NEW YORK STATE THRUWAY AUTHORITY
DEPARTMENT OF ENGINEERING

AMENDMENT NO. 3
TO

CONTRACT TAN 26-9A
D215077
NIAGARA SECTION PUMPHOUSE UPGRADE
ON I-190, MP N9.1
IN THE BUFFALO DIVISION
OF THE NEW YORK STATE THRUWAY
IN ERIE COUNTY

IN THE LETTING OF
MAY 6, 2026

TITLE OF PROJECT NIAGARA STREET PUMP STATION	CONTRACT NUMBER: D215077
LOCATION OF PROJECT 1776 NIAGARA STREET BUFFALO, NY	DATE: 4/24/26
TITLE OF DRAWING CIVIL SITE PLAN	DRAWING NUMBER: C-103

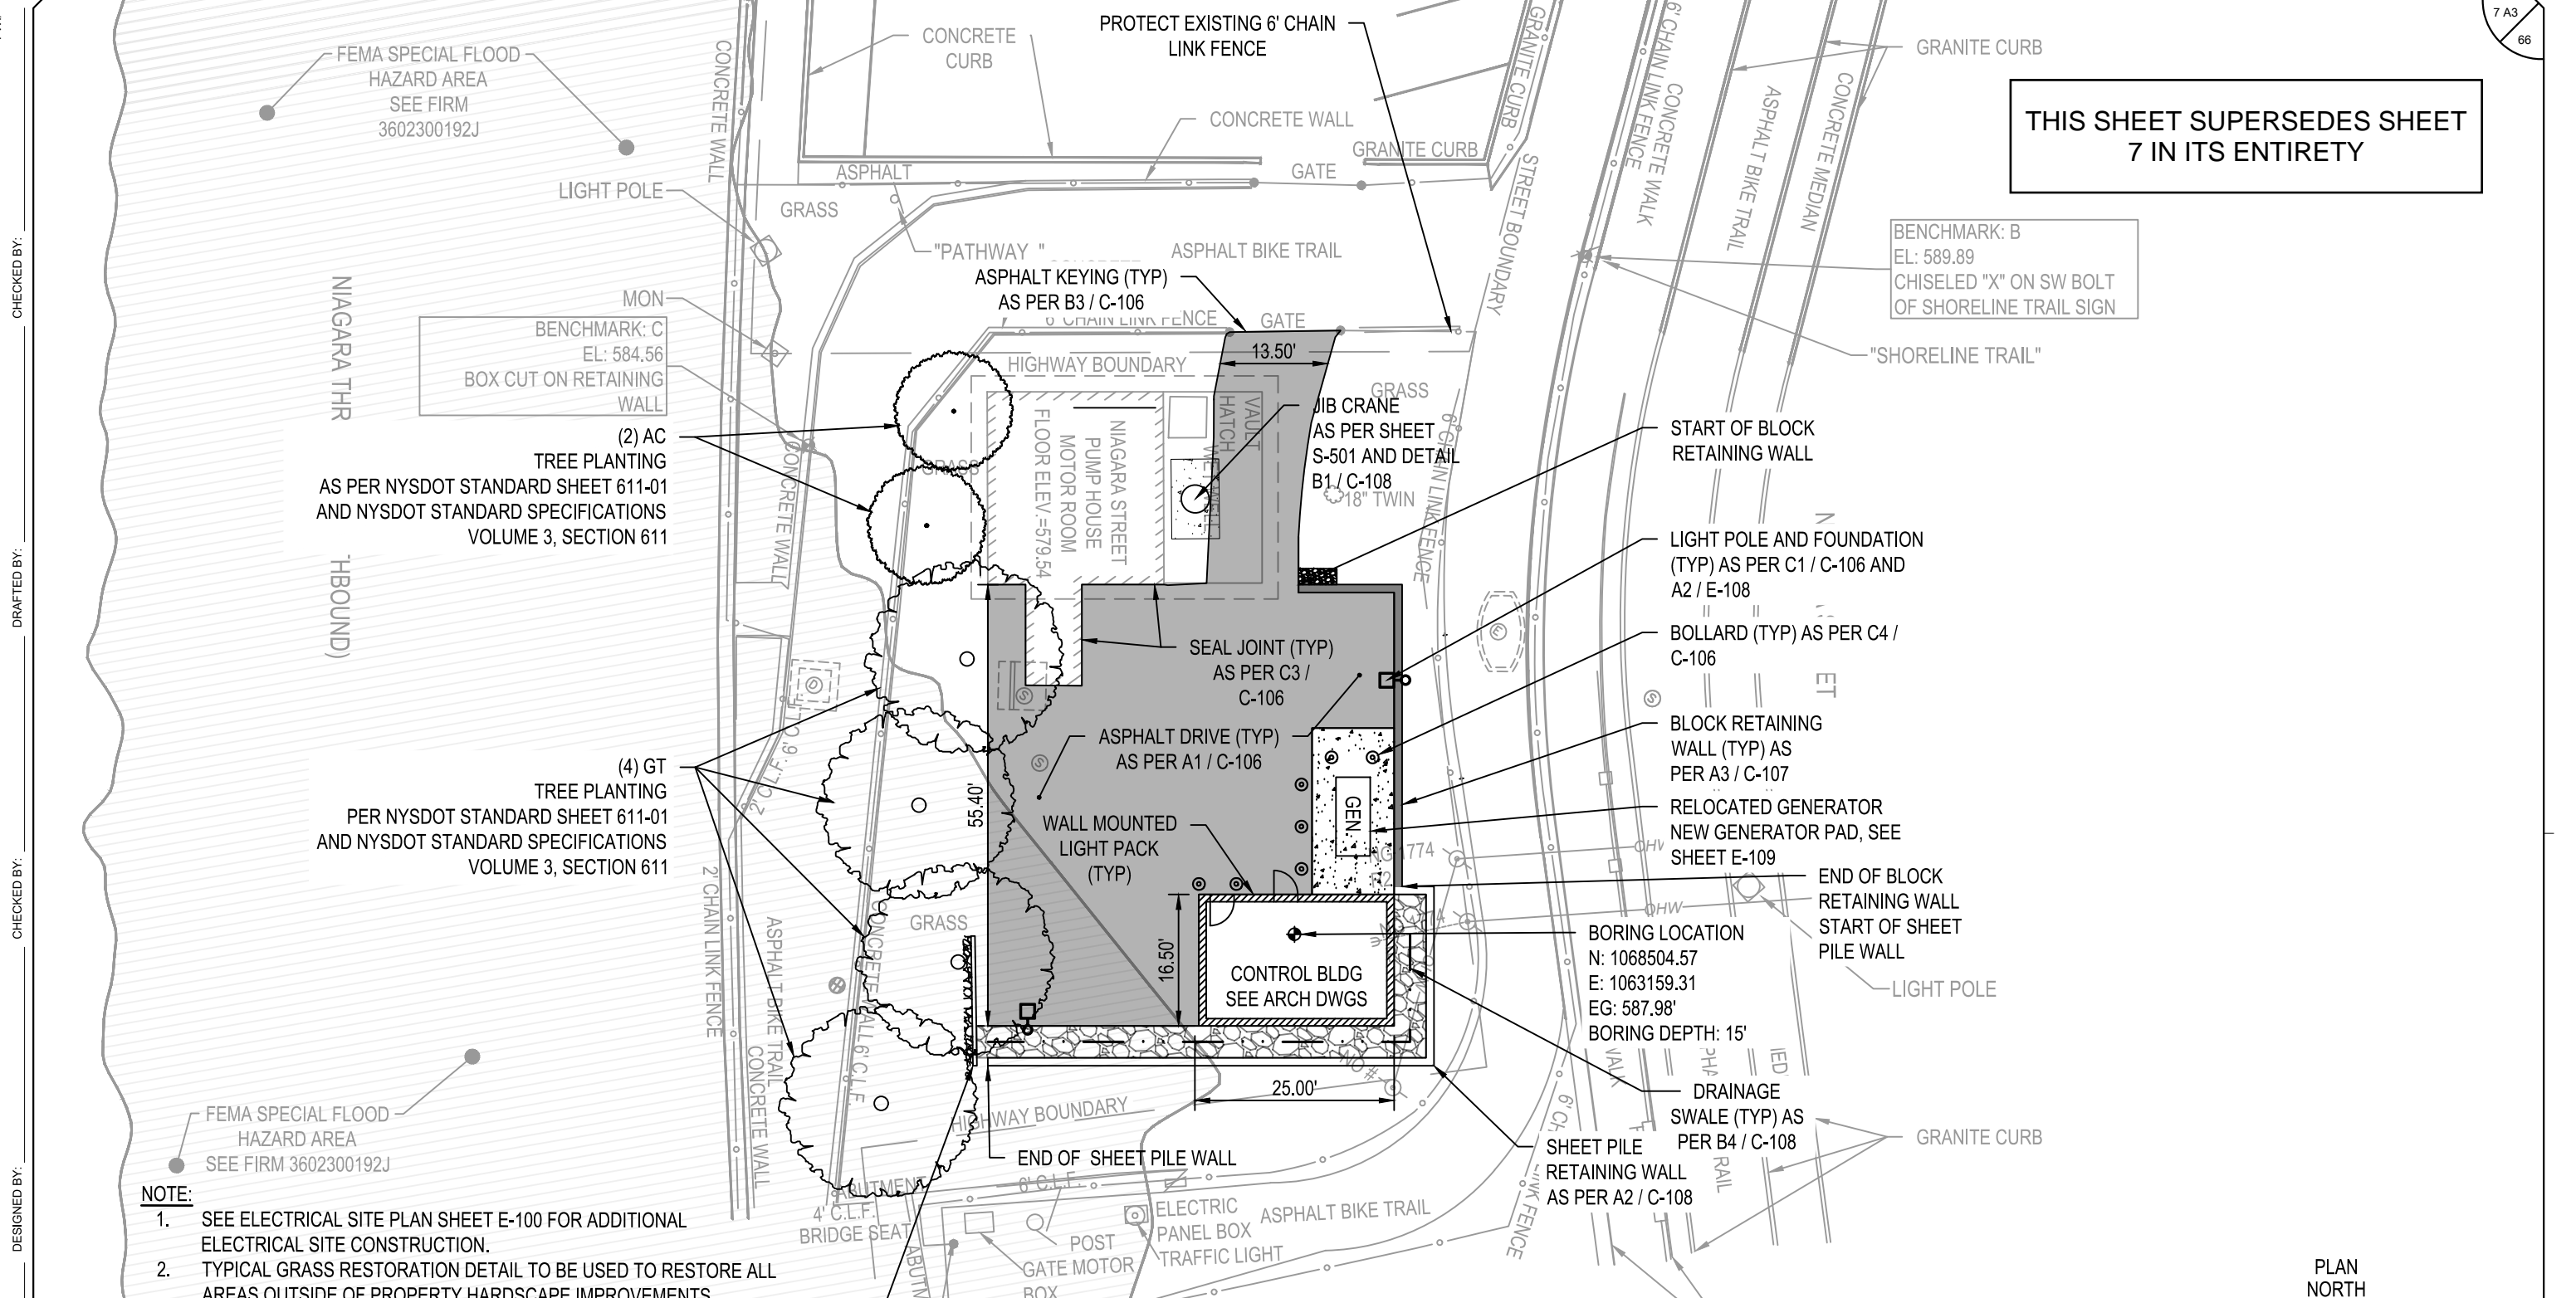
4. **DELETE** Drawing Number C-103, Sheet 7 of 66 and **SUBSTITUTE** with the attached Drawing Number C-103, Sheet 7-A3 of 66. A callout to the Light Pole and Foundation (TYP) has been updated to now also reference the additional foundation detail.

TITLE OF PROJECT NIAGARA STREET PUMP STATION	CONTRACT NUMBER: D215077
LOCATION OF PROJECT 1776 NIAGARA STREET BUFFALO, NY	DATE: 4/24/26
TITLE OF DRAWING CIVIL UTILITY PLAN	DRAWING NUMBER: C-105

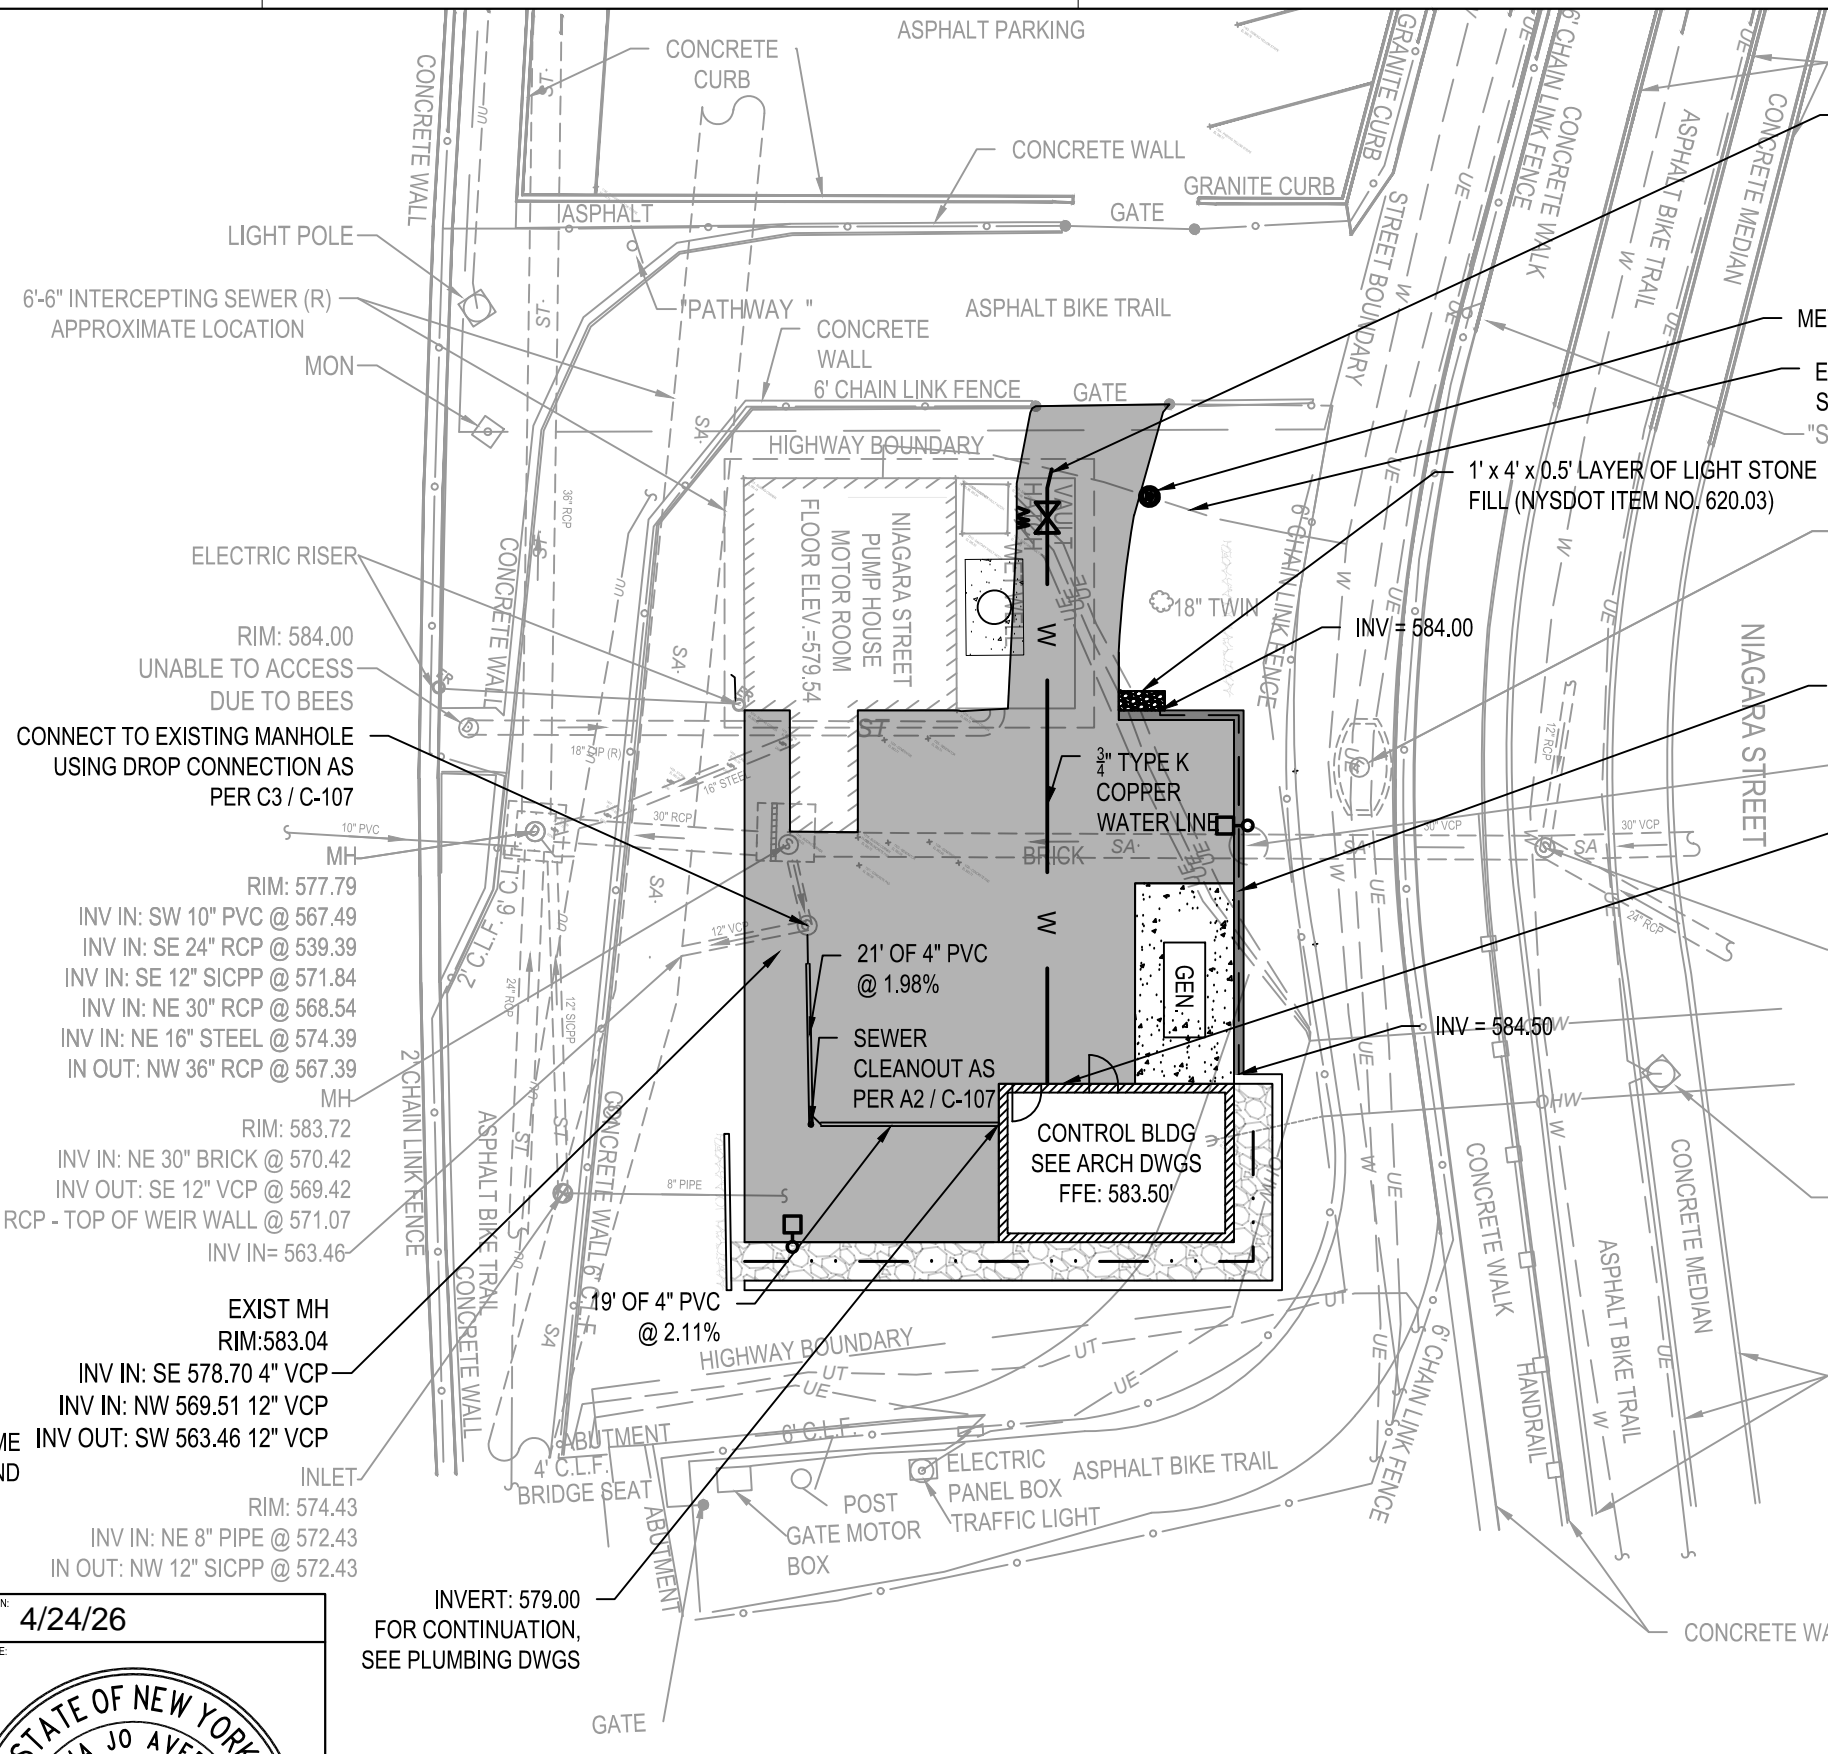
5. **DELETE** Drawing Number C-105, Sheet 9 of 66 and **SUBSTITUTE** with the attached Drawing Number C-105, Sheet 9-A3 of 66. The callout to the Existing Manhole for the sewer connection has been revised to reference the additional drop connection detail.

C1 LIGHT POLE FOUNDATION DETAIL
SCALE: N.T.S.

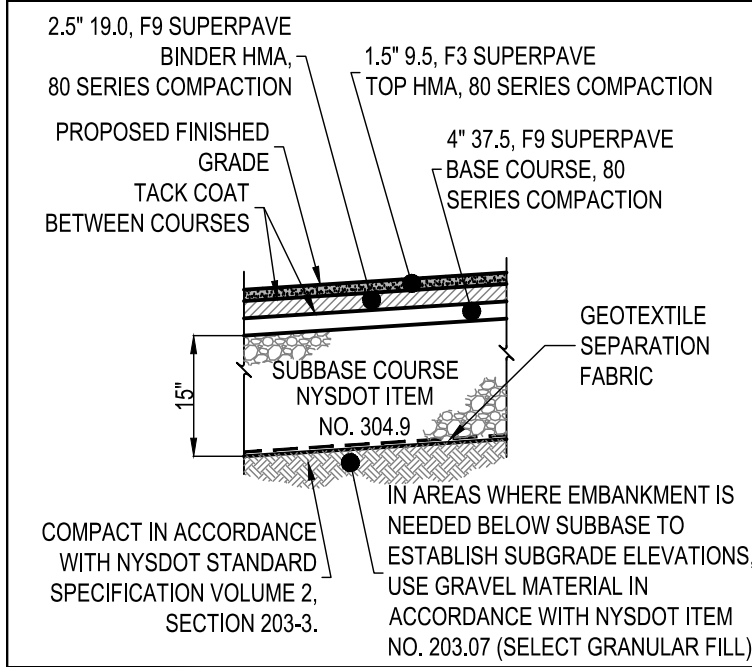
6. **DELETE** Drawing Number C-106, Sheet 10 of 66 and **SUBSTITUTE** with the attached Drawing Number C-106, Sheet 10-A3 of 66. A new C1 Light Pole Foundation Detail has been added and is now located on the upper left corner of the drawing.

C3 INSIDE DROP CONNECTION DETAIL
SCALE: N.T.S.

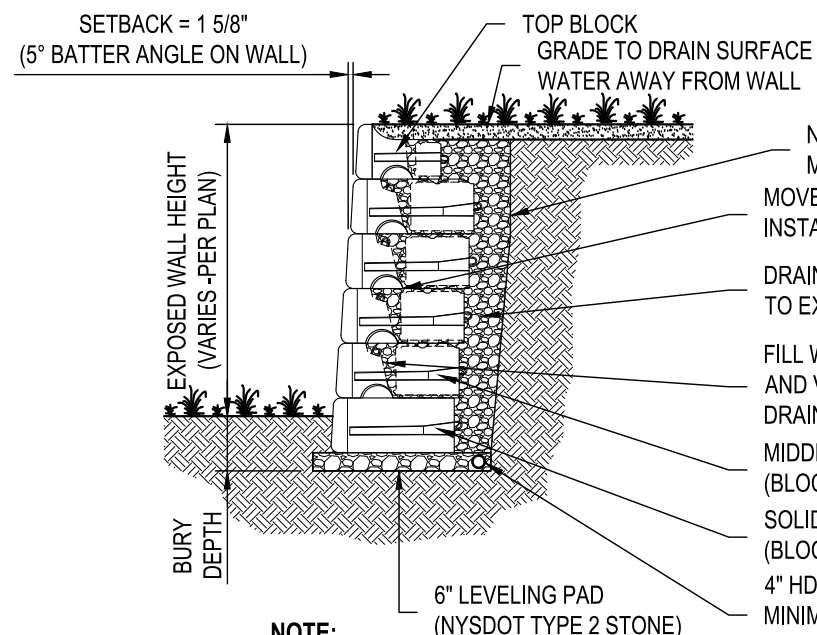
7. **DELETE** Drawing Number C-107, Sheet 11 of 66 and **SUBSTITUTE** with the attached Drawing Number C-107, Sheet 11-A3 of 66. A new C3 Inside Drop Connection Detail has been added and is now located on the upper right corner of the drawing.

NOTES:
1. A DROP PIPE SHALL BE PROVIDED FOR A SEWER ENTERING A MANHOLE AT AN ELEVATION OF 24 INCHES OR MORE ABOVE THE MANHOLE INVERT. ONLY INSIDE DROP ASSEMBLIES WILL BE ALLOWED.
2. INSIDE DROP LEG SHALL BE INSTALLED ON MANHOLE WALL LOCATED AS SHOWN OR AS APPROVED BY ENGINEER.

A2 TYPICAL STEEL SHEET PILE WALL DETAIL
SCALE: N.T.S.

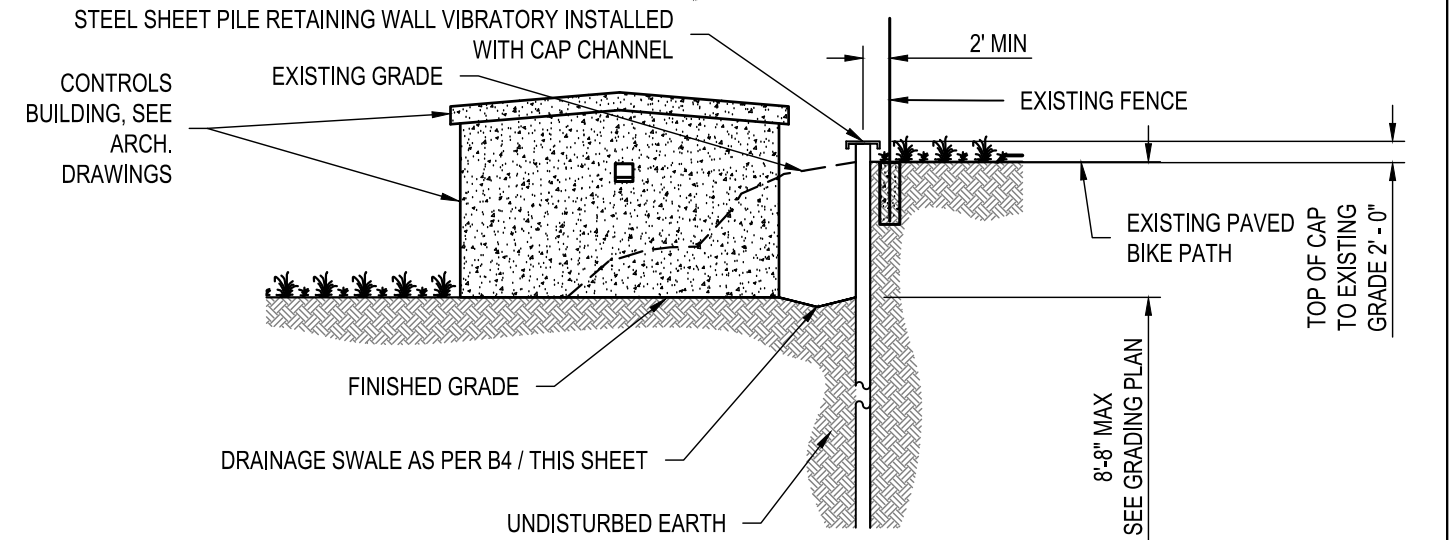
8. **DELETE** Drawing Number C-108, Sheet 12 of 66 and **SUBSTITUTE** with the attached Drawing Number C-108, Sheet 12-A3 of 66. A dimension has been added in the A2 Elevation detail to clarify the height of the sheet pile wall cap over existing grade.

C1 HANGER ATTACHMENT DETAIL
SCALE: NOT TO SCALE

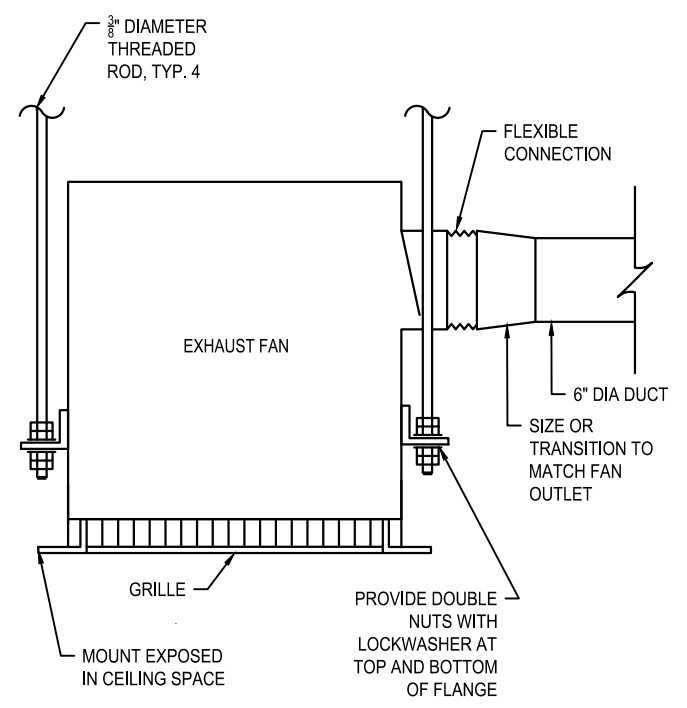
11. **DELETE** Drawing Number H-100, Sheet 43 of 66 and **SUBSTITUTE** with the attached Drawing Number H-100, Sheet 43-A3 of 66. Detail A1 has been updated with the revised fan selection as also identified in Drawing Number H-001 above. The A2 Floor Plan detail has been updated with a revised fan layout and new instructions. A new C1 Hanger Attachment detail has been added to accommodate the revised fan selection.
